[Docket No. FAA-I 9964731; Notice No. 96-161 FAA-98-4731-1
RIN 2120-AG65

Noise Certification Standards for Propeller-Driven Small Airplanes

ACTION: Notice of Proposed Rulemaking (NPRM).

2. Appendix G of part 36 is amended by revising sections G36.107(a), G36.201(b), including Figure G1, G36.201(c), G36.201(d)(1), G36.201(d)(4), and G36.301(b), including Figure G2, to read as follows:

Sec. G36.107 Noise Measurement Procedures.

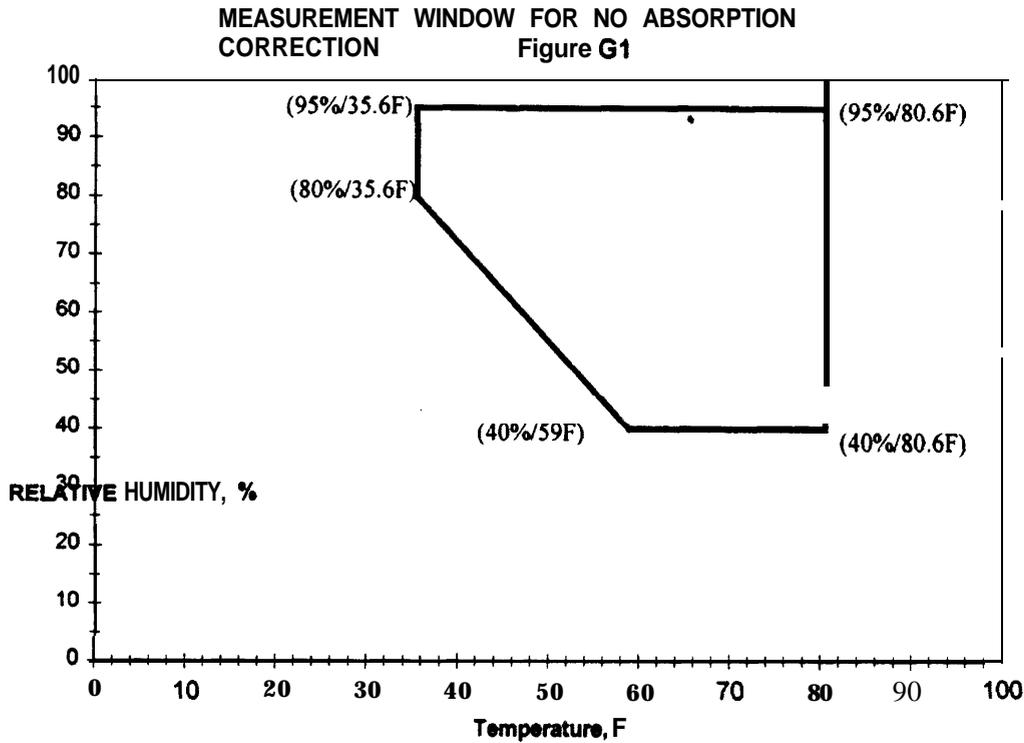
The proposed change to section G36.107(a) would require the microphone to be a pressure-type microphone with a protective grid that is 12.7 mm in diameter. The microphone would have to be mounted in an inverted position so that the diaphragm is 0.7 mm above and parallel

to a white-painted metal circular plate. The plate would have to be 40 cm in diameter and at least 2.5 mm thick. The plate would have to be placed horizontally and flush with the surrounding ground surface with no cavities below the plate. The microphone would have to be located three-quarters of the distance from the center to the edge of the plate along a radius normal to the line of flight of the test airplane.

The proposed changes, which would make the U.S. regulations consistent with the JAR, are supported by numerous studies, technical papers, and discussions with interested groups. The technical data indicate that an inverted microphone that measures reflected noise from a metal plate at ground level produces more consistent and reliable data. A microphone that is four feet above the ground is much more likely to be affected by variable ground reflections that can interact with the noise produced by the aircraft being measured. The microphone height reduction and the metal plate substantially eliminate these variations.

However, studies also show that measurements using the inverted microphone and metal plate technique produce consistently higher noise levels than those produced under the current procedure, with the difference being about 3 dB(A). Therefore, to maintain the present level of noise stringency, a corresponding change to section G36.301 (b) is necessary as discussed below.

(a) The microphone must be a pressure type, 12.7 mm in diameter, with a protective grid, mounted in an inverted position such that the microphone diaphragm is 0.7 mm above and parallel to a white-painted metal circular plate. This white-painted metal plate shall be 40 cm in diameter and at least 2.5 mm thick. The plate shall be placed horizontally and flush with the surrounding ground surface with no cavities below the plate. The microphone must be located three-quarters of the distance from the center to the back edge of the plate along a radius normal to the line of flight of the test airplane.

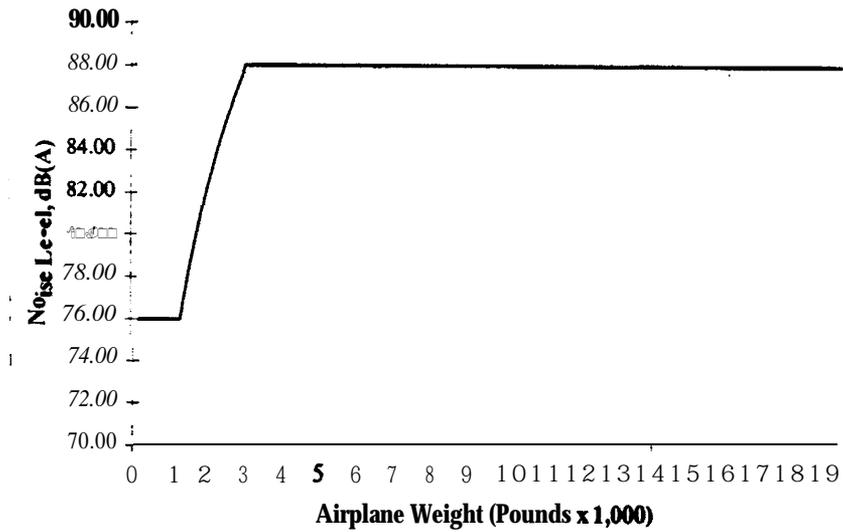
Current section G36.201 (b) requires atmospheric absorption correction for noise data obtained when the test conditions are outside those specified in appendix G, figure G 1. Noise data collected outside the prescribed range of figure G1 are required to be corrected to 77 degrees F and 70 percent relative humidity by an FAA approved method. The FAA is proposing to change the 77 degrees F reference temperature to 59 degrees F, to be consistent with the ambient temperature requirement in current section G36.111 (b) (2) that is used for performance calculations. By making the reference temperatures consistent for absorption and performance, delays and confusion that have been caused by the inconsistency in the current rule would be eliminated.

(b) Atmospheric absorption correction is required for noise data obtained when the test conditions are outside those specified in Figure G 1. Noise data outside the applicable range must be corrected to 59 F and 70 percent relative humidity by an FAA approved method.

Sec. **G36.107** Noise Measurement Procedures.

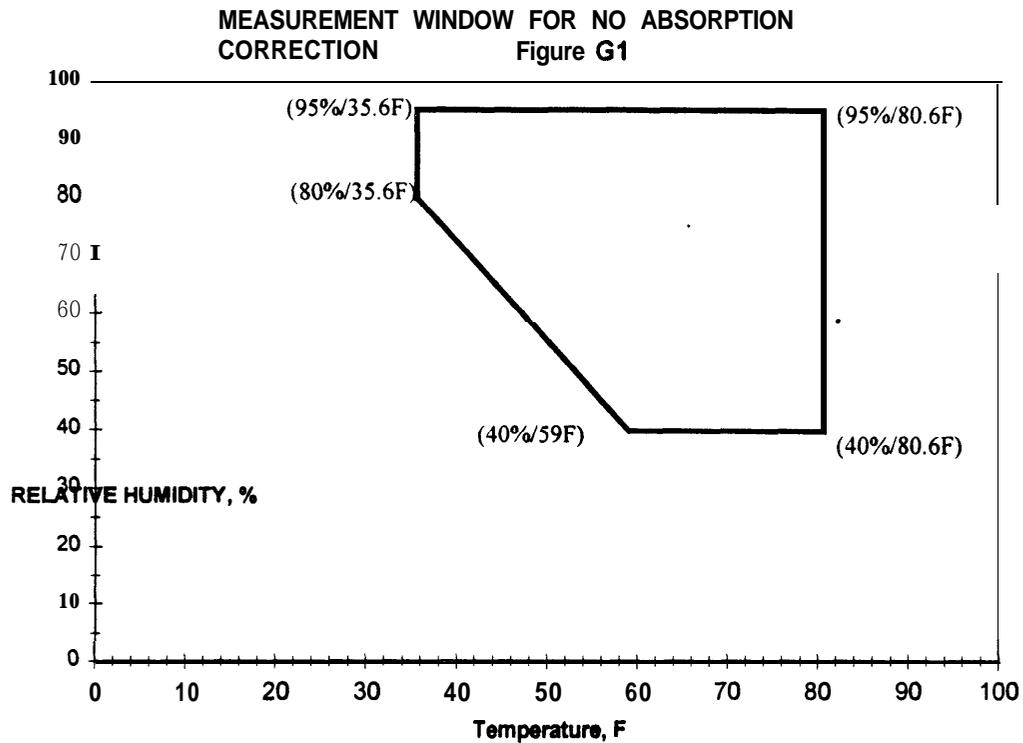
The proposed change to section **G36.107(a)** would require the microphone to be a pressure-type microphone with a protective grid that is 12.7 mm in diameter. The microphone would have to be mounted in an inverted position so that the diaphragm is 0.7 mm above and parallel to a white-painted metal circular plate. The plate would have to be 40 cm in diameter and at least 2.5 mm thick. The plate would have to be placed horizontally and flush with the surrounding ground surface with no cavities below the plate.

The microphone would have to be located three-quarters of the distance from the center to the edge of the plate along a radius normal to the line of flight of the test airplane.

However, studies also show that measurements using the inverted microphone and metal plate technique produce consistently higher noise levels than those produced under the current procedure, with the difference being about 3 **dB(A)**. Therefore, to maintain the present level of noise stringency, a corresponding change to section **G36.301(b)** is necessary as discussed below.

(a) The microphone must be a pressure type, 12.7 mm in diameter, with a protective grid, mounted in an inverted position such that the microphone diaphragm is 0.7 mm above and parallel to a white-painted metal circular plate. This white-painted metal plate shall be 40 cm in diameter and at least 2.5 mm thick. The plate shall be placed horizontally and flush with the surrounding ground surface with no cavities below the plate. The microphone must be located three-quarters of the distance from the center to the back edge of the plate along a radius normal to the line of flight of the test airplane.

NOISE LEVELS vs AIRPLANE WEIGHT
FIGURE G2

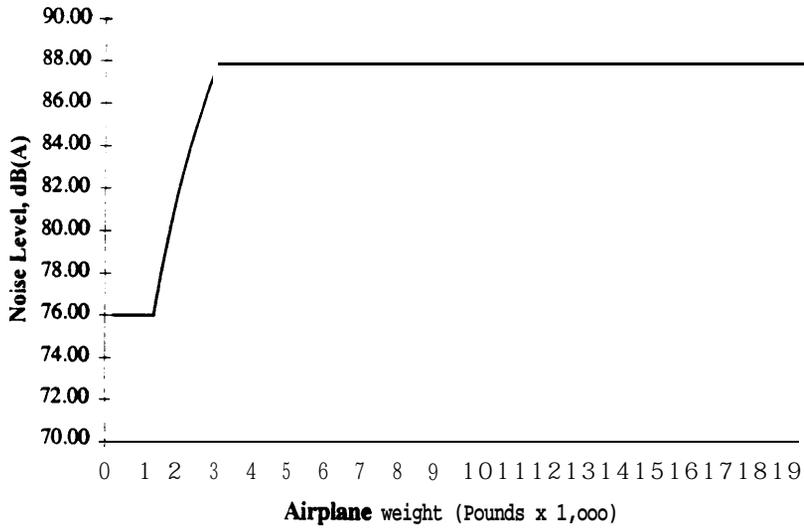
As previously discussed, considerations of microphone location, configuration, and resulting noise limits are interrelated. Since the proposed changes to the noise measurement procedures of section **G36.107(a)** would result in increases in the measured noise levels of about 3 dB(A), the FAA proposes to increase the limits in section **36.301(b)** from 73 dB(A) to 76 dB(A) and from 85 dB(A) to 88 dB(A). This change would account for the revised microphone height and configuration requirements. The increased limit is not expected to result in any increase or decrease in the noise stringency requirements of the current rule.

In addition to the dB(A) changes discussed, the FAA is proposing a change to the interpolation requirement of section G36.30 1 (b). For weights greater than 1,320 pounds, the allowable dB(A) would increase “with the logarithm of airplane weight at the rate of 9.83 dB(A) per doubling of weight until the limit of 88 dB(A) is reached . . .” rather than at the rate of 1 dB/165 pounds up to 85 dB(A) at 3,300 pounds, as under the current rule. This change would harmonize interpolation under the FAA regulation with the comparable JAA regulation without change in noise stringency of the present Appendix G.

(b) The noise level must not exceed 76 dB(A) up to and including aircraft weights of 1,320 pounds (600 kg). For aircraft weights greater than 1,320 pounds, the limit increases from that point with the logarithm of airplane weight at the rate of 9.83 dB (A) per doubling of weight, until the limit of 88 dB (A) is reached, after which the limit is constant up to and including 19,000 pounds (8,618 kg). Figure G2 shows noise level limits vs airplane weight.
